Attachment 2 – Extent of Clays

Attachment 2 Figure 2-1 NRC Determined Distribution of Mudstone between Zones 1 & 2

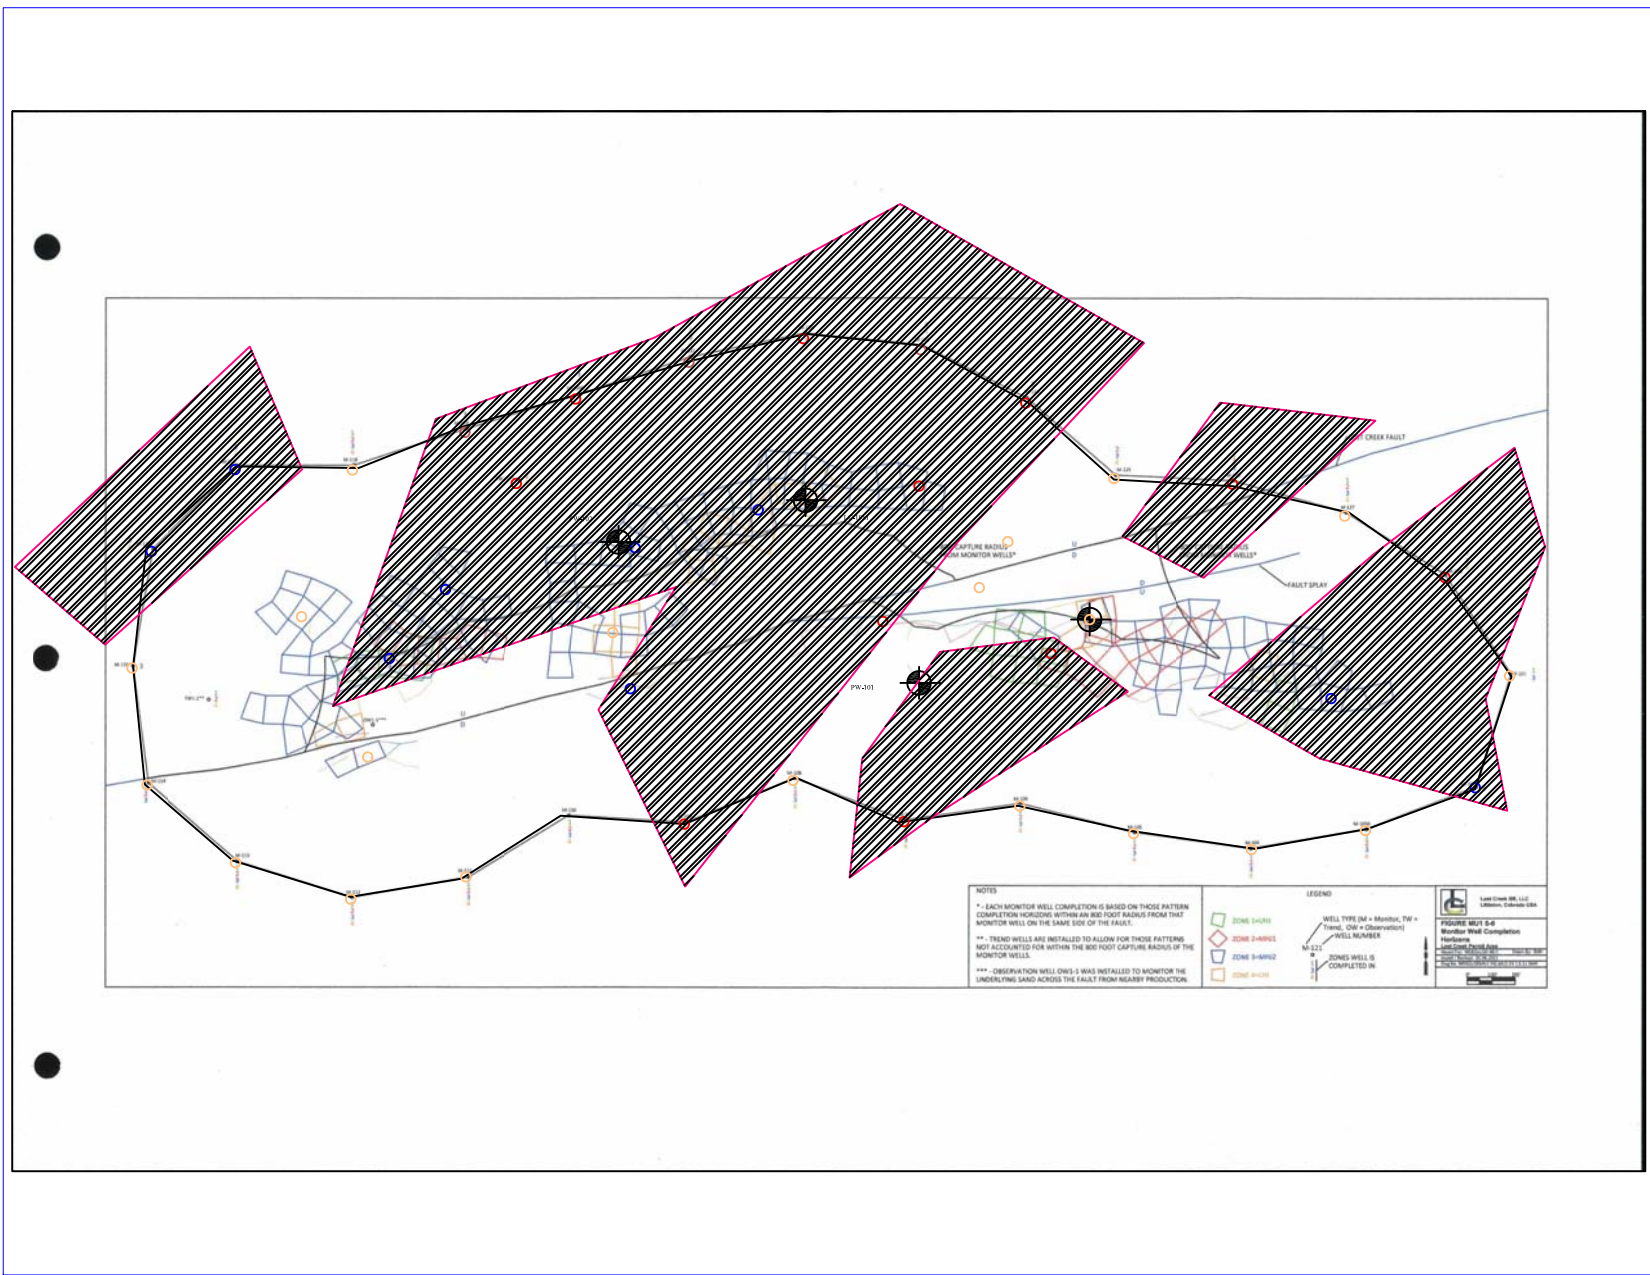
Lost Creek did not provide any mapping on the intermediate mudstones. Because of staff’s concerns regarding the vertical anisotropy, staff reviewed the available information to establish the extent of the intermediate mudstones. The data use in the evaluation is summarized in Attachment 1 Table 1-1. This information is graphically displayed for the distribution of the mudstones between Zones 1 & 2, between Zones 2 & 3, and between Zones 3 & 4 is shown on Attachment 2 Figures 2-1, 2-2 and 2-3, respectively.

Although not contiguous throughout Mine Unit 1, the mudstones may be locally extensive for several of the proposed production areas.
